INDEPENDENT EXPERT EVIDENCE ADVICE

AMENDMENT C223yara TO THE YARRA PLANNING SCHEME 81-95 BURNLEY STREET & 26 DOONSIDE STREET RICHMOND

For: Yarra City Council

May 2020

Figure 1: Indicative Framework Plan

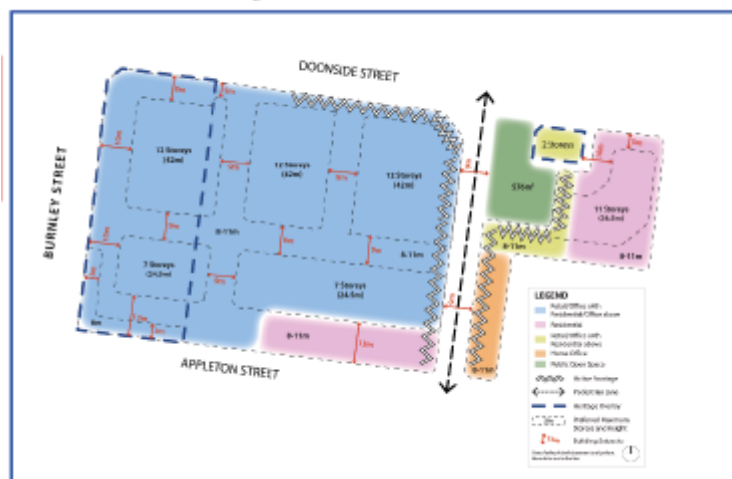
172. I recommended to Council, that consistent with this that they amend the proposed Figure 1 Framework Plan to the south eastern envelope as shown in paragraph 22 drawing 2 to amend the 7 storey building addressing the Appleton Street frontage to create a visual break of 9m between east and west forms above level 4 to provide reduced perceived bulk, enhanced skyline opportunities and improved campus spatial breaks consistent with the principles underpinning the scale and longitudinal footprints characterising the balance of the site.

Shadow studies with recommended adjustments to the proposed Amendment C223 to the Yarra Planning Scheme.

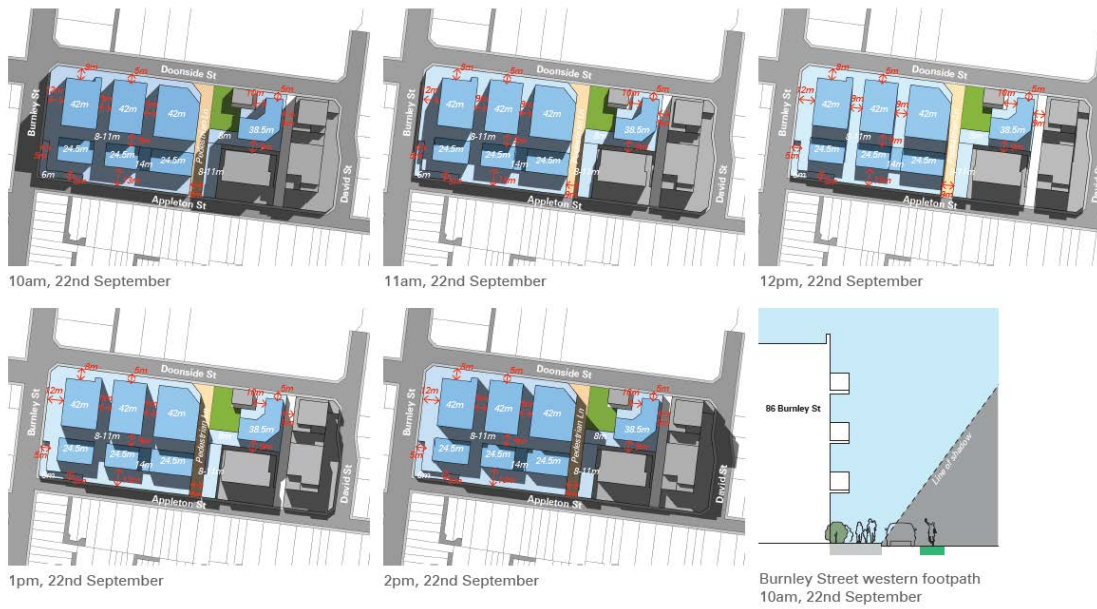
Recommendation 1: Protect the western footpath of Burnley Street from overshadowing in the morning after 10am at the September Equinox.

Recommendation 3: Create a visual break of 9m between east and west forms above level 4 to the south eastern 7 storey building.

Recommendation 5: Lower the podium adjoining 27 Appleton Street to a maximum 8m height. Provide a minimum 9m setback from the outermost western face of balconies and habitable rooms of the adjoining tower at 44 Doonside Street.
